CITY OF OREGON CITY HISTORIC REVIEW BOARD (HRB) AGENDA

Virtual Meeting
Tuesday, February 28, 2023 at 7:00 PM

2. GLUA-23-00001 and HR 23-00001 -204 Jefferson Street. Alterations & additions on a Historic Structure (Frank and Annie Busch House) in the McLoughlin Conservation District.
3. GLUA-23-00003 and HR 23-00002 -100 Center Street Historic Review for solar panel installation on street-facing roof planes on a designated structure in the McLoughlin Conservation District

**PRESERVATION GRANT REQUEST
HISTORIC REVIEW BOARD
June 21, 2022**

Figure 4- Site Plan

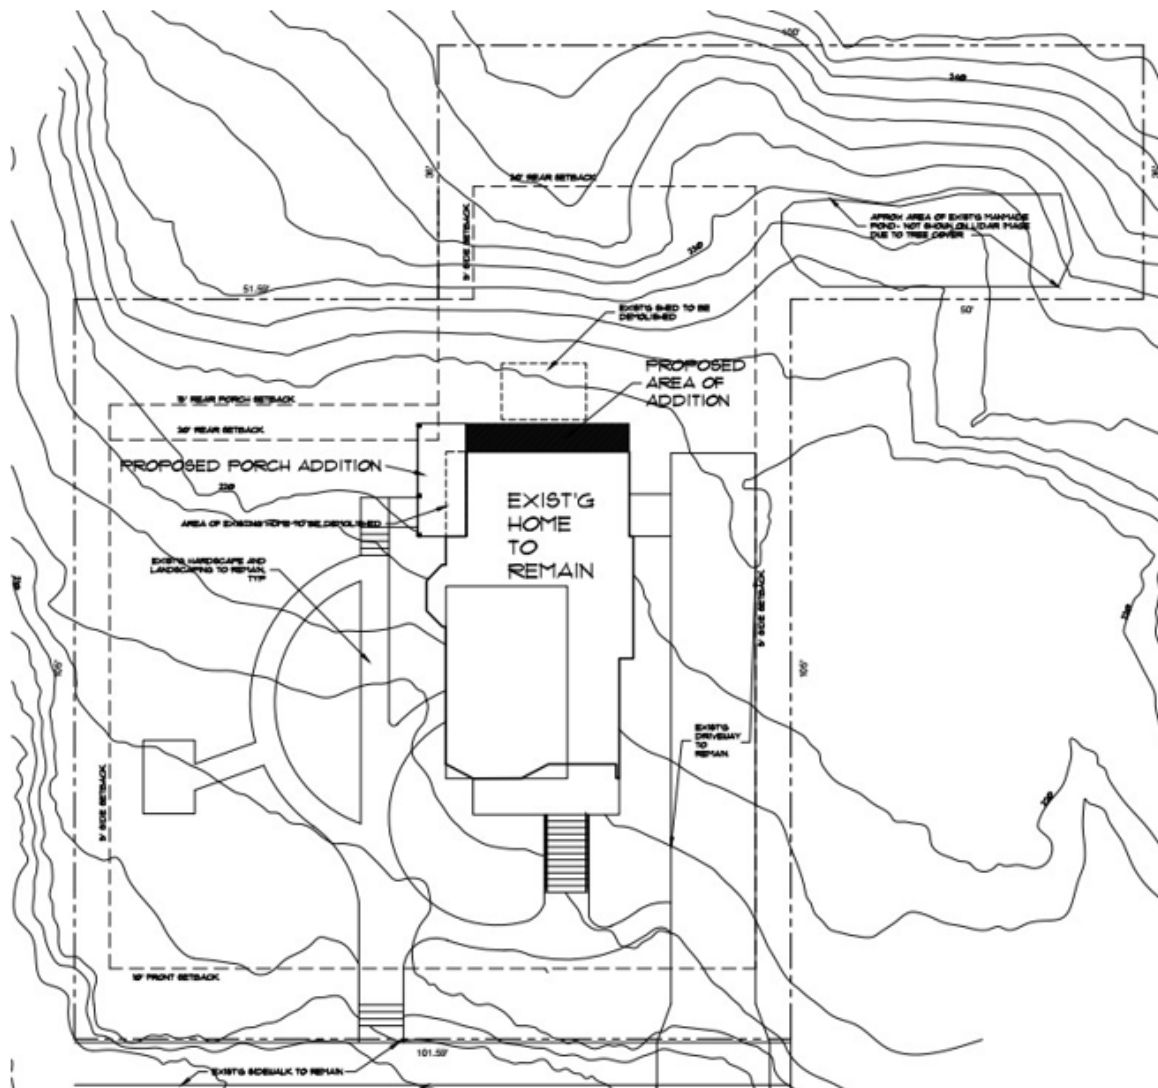
Staff Finding: Complies with Conditions. The applicant proposes to add a net 303-square-foot addition and 94 foot covered porch on the rear of the house. The addition is a single story with a gabled roof. The design is compatible through its scale and proportion and its use of compatible but slightly different materials as conditioned. The massing and materials proposed on the exterior of the addition are compatible with the original Victorian structure. Replicating the spindlework and gingerbread elements of the original home are not proposed since the addition will be at the rear of the home and to differentiate this as an addition to the historic structure.

3. To further differentiate the new addition from the historic volume, the applicant shall provide a slightly differentiated drop siding width. Please provide staff with the proposed siding spec prior to the release of Building Permits. (P)

Panel configuration

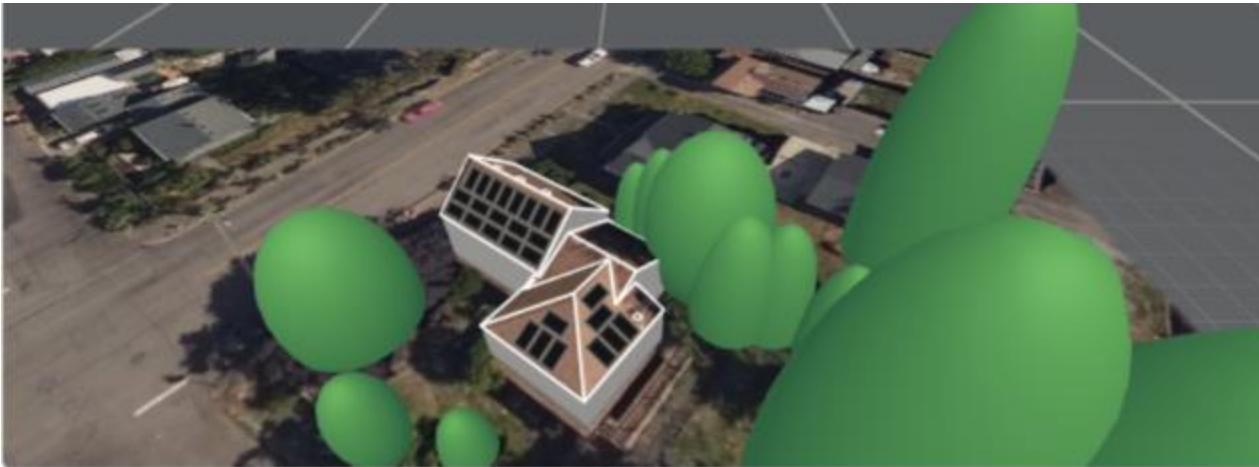
Compatibility with Historical Features: The panels would be placed on the medium-pitch roof. The panels would not alter the pitch of the roof but would change the appearance of the roof and would be visible from the street. Generally, the Secretary of Interior Standards have been applied to find that roof-mounted solar panels may be compatible if they are on a rear-facing area, are minimally visible, or on a new addition to a historic building (see Exhibit 5).
